**JOINT APPLICATION OF OTTER TAIL)
POWER COMPANY AND MONTANA-DAKOTA)
UTILITY FOR AN ADVANCE)
DETERMINATION OF PRUDENCE FOR ITS)
BIG STONE AIR QUALITY CONTROL)
SYSTEM PROJECT**

**DOCKET NO. PU-11-165
DOCKET NO. PU-11-163**

INITIAL TESTIMONY

RICHARD S. HAHN

14 **Figure 1**

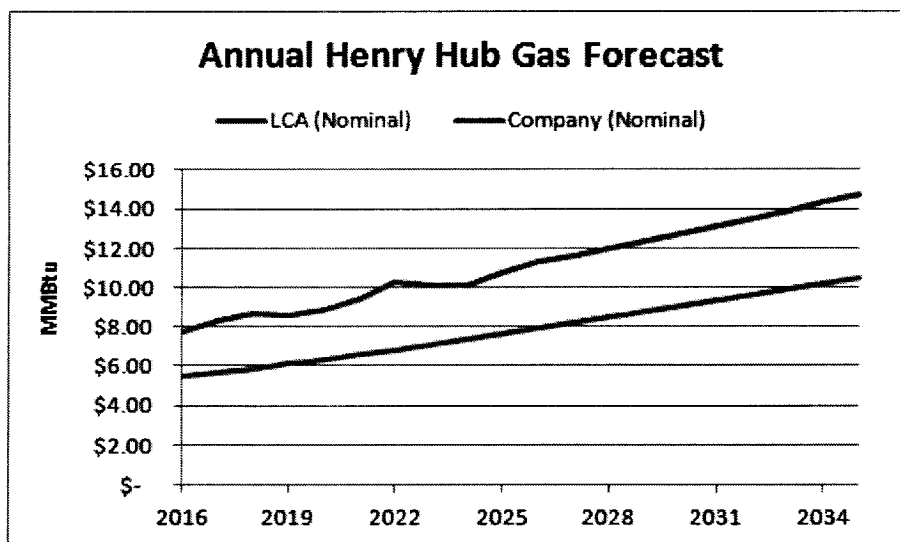
7 A. The fuel forecasts in the Burns & McDonnell study were taken from the 2010
8 IRP. This means that the natural gas commodity forecast was 1½ years old at the
9 time of the filing of this application. Since that time, injections of new supplies
10 and new pipeline capacity have led to lower gas prices and the market outlook for
11 the future is similarly suppressed, as natural gas futures are significantly below
12 the company's 2009 forecast (see Figure 1 for a comparison of natural gas price
13 forecasts).

8 **Figure 2**

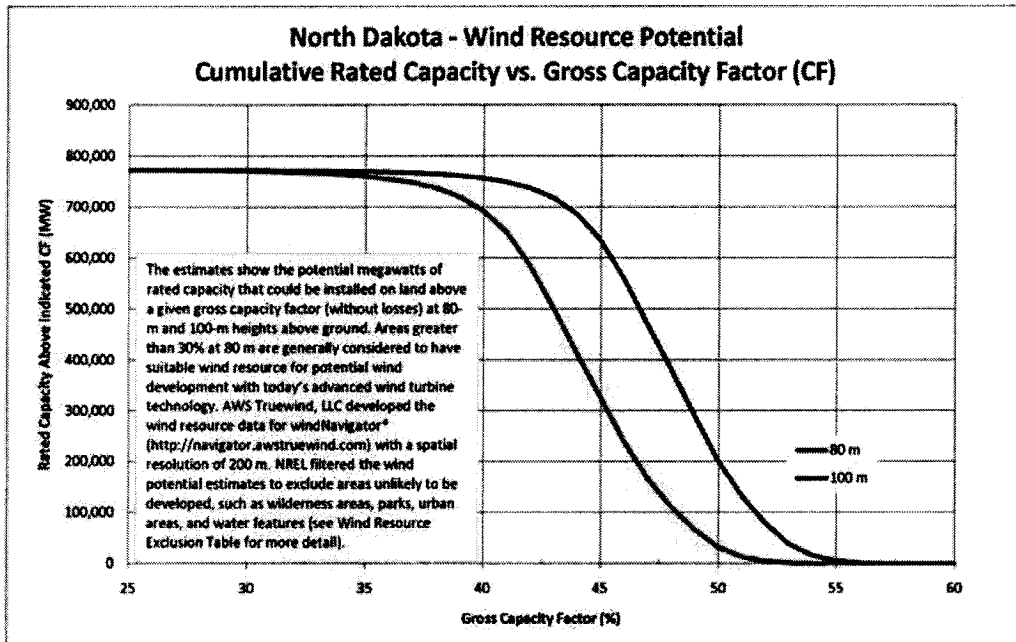
20 A. This capacity factor is slightly low given the strong wind resource available in
21 North Dakota. The National Renewable Energy Laboratory recently conducted a

1 study of wind potential in the United States. This study produced charts showing
 2 the amount of wind potential by state at different capacity factors. The North
 3 Dakota chart reproduced in Figure 2 below shows that there is about 25,000 MW
 4 of wind potential at a gross capacity factor of 50% and above. Given that a 50%
 5 gross capacity factor is equivalent to a 42.5% net capacity factor⁷, there is the
 6 potential for 25,000 MW of wind facilities of 42.5% capacity factor and above in
 7 the state.

Figure 3

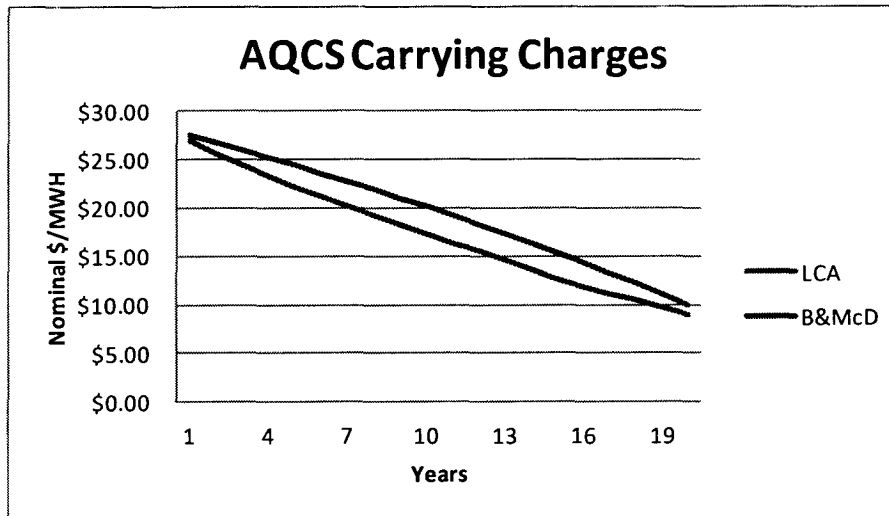
11 A. I believe that the spreadsheet model does not accurately simulate the cost of
12 service model that is used in utility rate setting processes. The spreadsheet model
13 does not include any accelerated depreciation for income tax purposes. It
14 includes a different treatment for debt and equity. Specifically, the spreadsheet
15 model uses a rate base calculation for equity, while using a principal and interest
16 loan calculation for the debt portion of capitalization. These assumptions would
17 affect the fixed costs that recover the invested capital. To assess the impact of
18 these assumptions on these fixed costs, I used La Capra Associates' revenue
19 requirements model with the Companies' cost assumptions to estimate the annual
20 fixed costs for the AQCS. Figure 3 below shows the annual dollars per MWH
21 fixed costs using the spreadsheet and the La Capra models. The graph shows that
22 the La Capra model yields lower fixed costs than does the spreadsheet model.

Figure 4

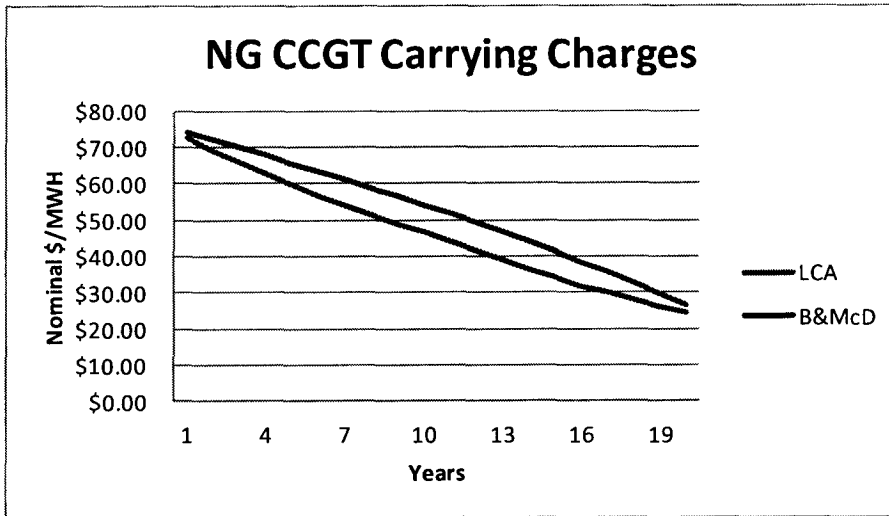
Figure 4 below presents a similar graph but for the NG CCGT option. The fixed

costs from the La Capra model are also lower.

Figure 6

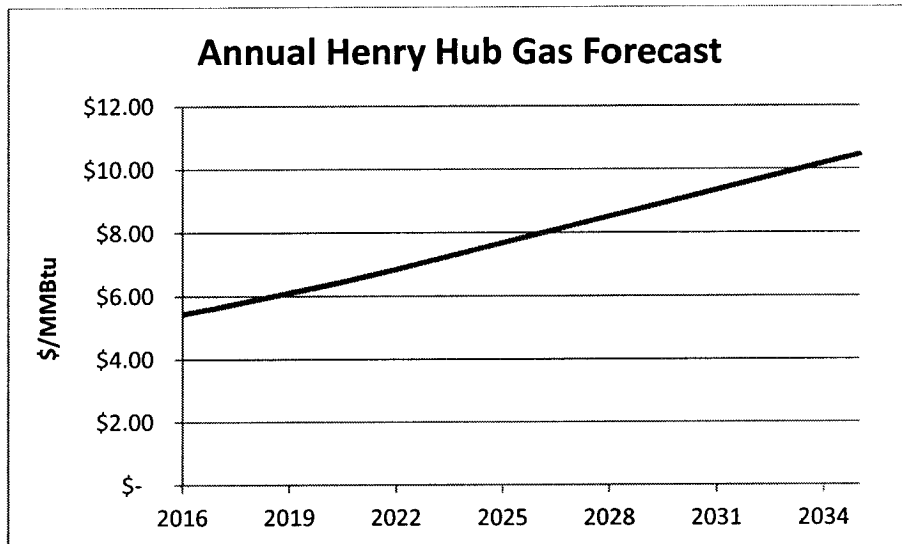
17 A. For the NGCC plus wind scenario I made several adjustments. First, I adjusted
18 for the cost of service changes as in the Big Stone AQCS scenario. Next, I
19 excluded the stranded cost allocation. Then, I adjusted the cost of new wind to be
20 \$42 per MWH in 2016 levelized dollars. Finally, I adjusted the natural gas
21 forecast to reflect average Henry Hub futures during the month of April 2011 (see
22 Figure 6).

3 **Figure 7**

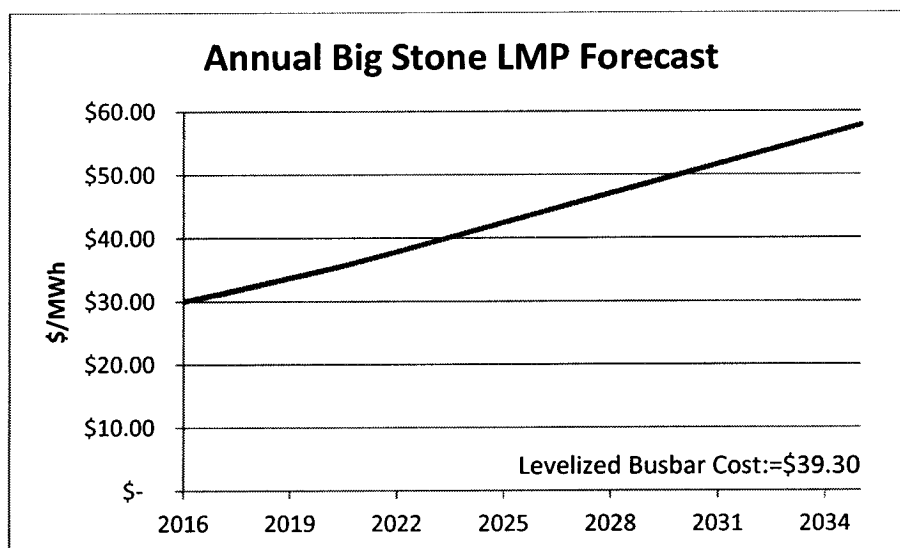
5 A. I started with the NGCC plus wind scenario as modeled above. I added market
6 purchases to the available assumptions and set them to 34% of the replacement
7 energy needed. Then I replaced the CC cost and performance information with
8 comparable data for a CT instead. I assumed a 10% capacity credit for wind
9 resources and added 427.5¹² MWs of CTs to ensure that the capacity position was
10 roughly identical to the AQCS scenario. The CTs were presumed to run only
11 enough to generate energy (after considering the wind and market purchases) that
12 Big Stone would have produced so that the scenario was on equal footing with the
13 AQCS scenario. For pricing of the market purchases I took the natural gas
14 forecast listed above and applied an average market heat rate of 5,460 Btu per

1 KWH¹³ (see Figure 7 for the LMP forecast). Applying a market heat rate to a
 2 forecast of natural gas prices is a common way to develop LMPs.

Figure 10

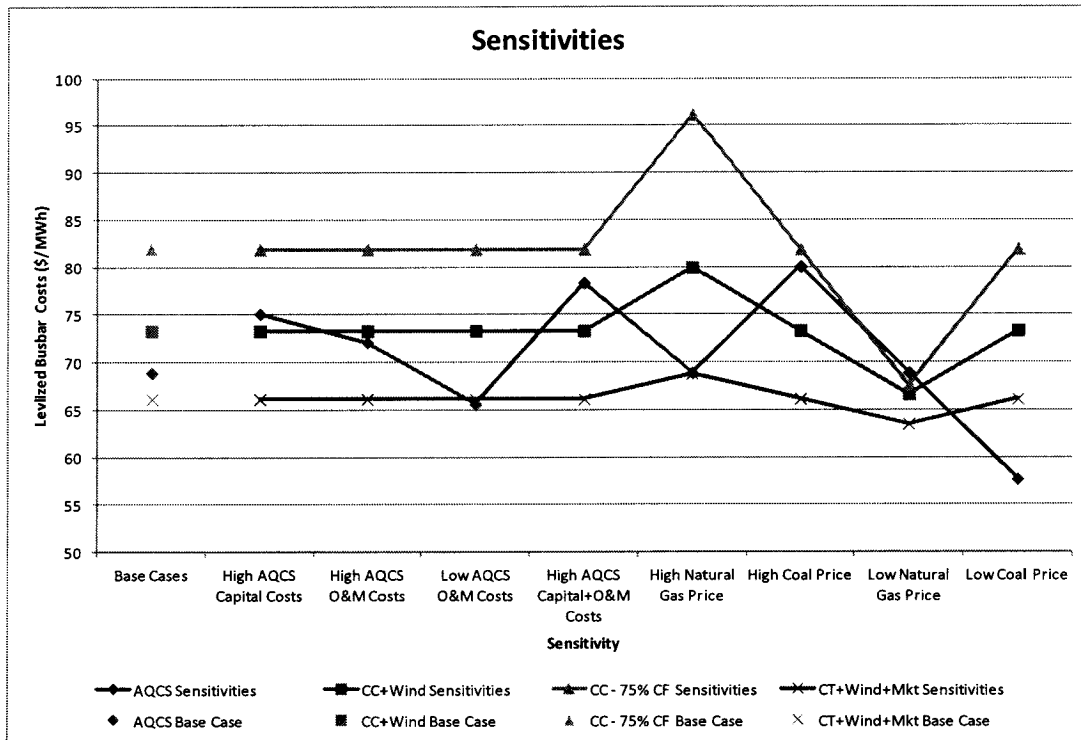
8 A. There were several sensitivities where the alternatives were competitive with the
 9 AQCS, in particular the case with market purchases. These scenarios were the
 10 AQCS coming in 30% over budget, AQCS O&M costs increasing by 30% or coal
 11 costs being up 30% or natural gas costs being down 30%. There were also
 12 multiple sensitivities in which the economic advantage of the AQCS increased,
 13 including low coal, low AQCS O&M and high natural gas. Even the high AQCS
 14 O&M sensitivity did not completely remove the advantage in economics enjoyed
 15 by the AQCS except with respect to the market case. Figure 10 shows the results
 16 of the sensitivities.
